1968 Corvette: Service Bulletin: Refrigerant Leak

Bulletin No: 68-T-56

Date: July 12, 1968

(FIGURE 1)

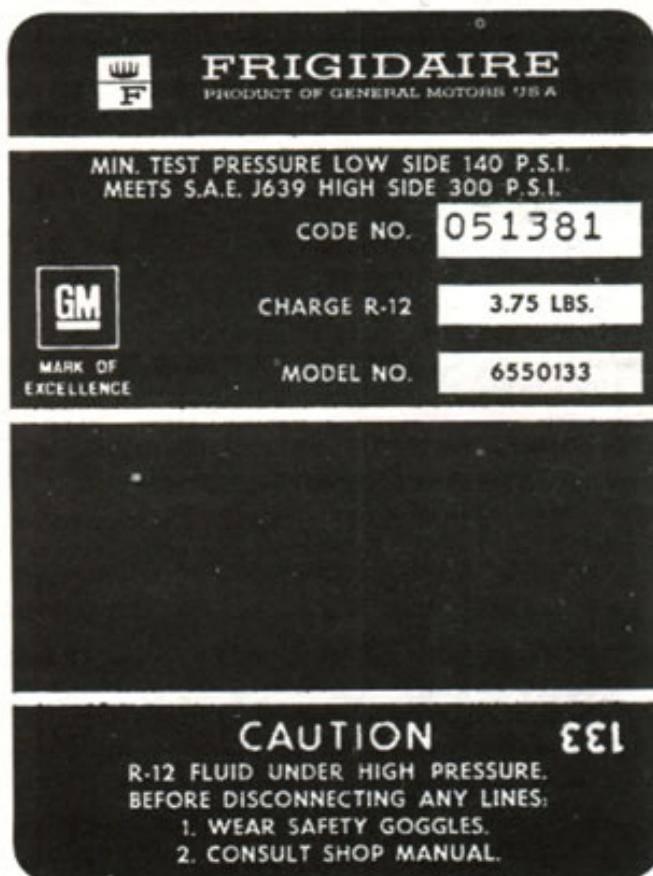
In production, the suspected seals were used between September 1, 1967 and March 18, 1968 and again between April 22, 1968 and April 29, 1968. Compressors built within these dates may be identified by noting the date stamped on the identification tag (See Fig. 1) located on top of the compressor.

Build date code should be within the following series of numbers:

090171 - 031881

and

042281 - 042981

1. Discharge the system and remove the connector block from the rear of the compressor.
2. Remove two (2) O-rings from exposed cavities and discard.
3. Install new O-rings, Part No. 5887997, and reverse Steps 1 and 2.

Note: All new O-ring packages will be date stamped as of May 1, 1968. Any other O-ring should not be used. O-rings should be dipped in clean Frigidaire 525 viscosity refrigerant oil and immediately placed in suction-discharge port cavities. Do not drain or wipe excess oil from O-ring.

4. Add a dab of white paint after the shift digit on identification tag.
